TO: The Board of Selectmen Courtesy of the Town Manager
FROM: The Roads and Right of Way Committee
DATE: March 18, 2014
RE: Public Access in the Baxter Road and Sankaty Beach Areas

ATTACHMENT

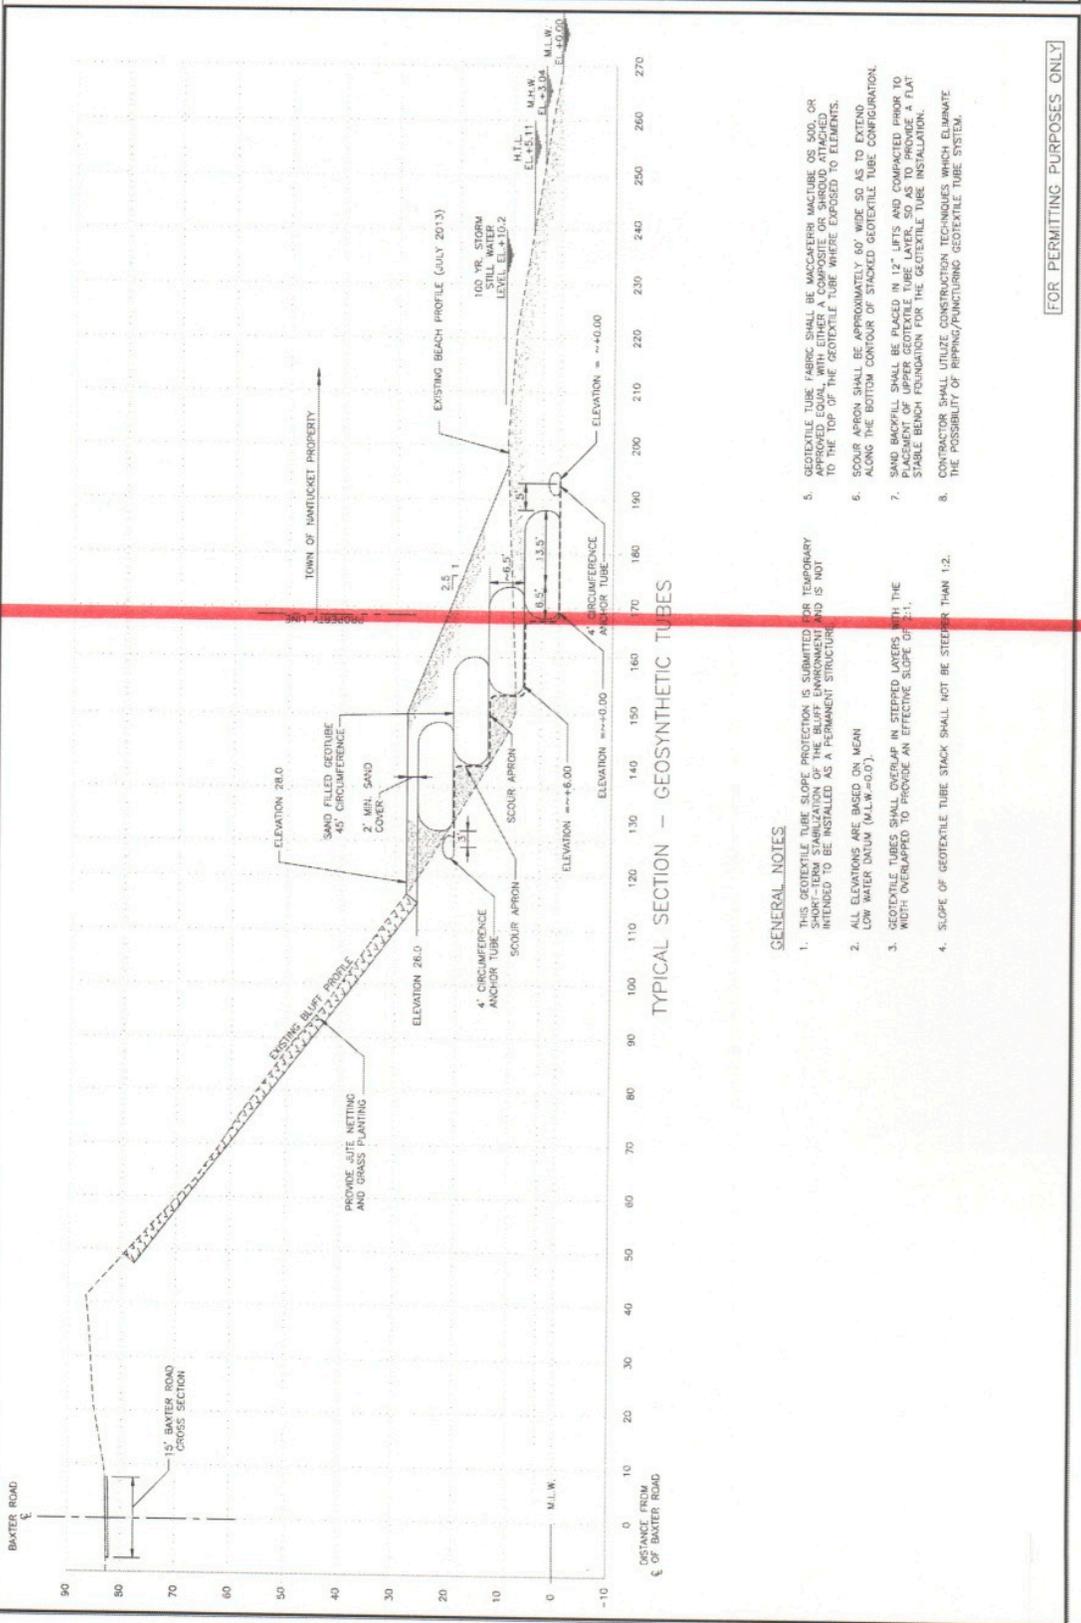
In addition, we advise the Board to consider the impacts of whatever erosion-control measures the Town supports on the public’s ability to use the beach it owns. Safe access along what beach is still public should be a priority. [See Attachment for cross section of the then proposed geotextile engineering structure, dated October 26, 2013. **Red line** denotes boundary of Town property that lies seaward.] Unless some semblance of beach is preserved below the bluff for citizens to pass and re-pass safely, there would be no need for OBB.
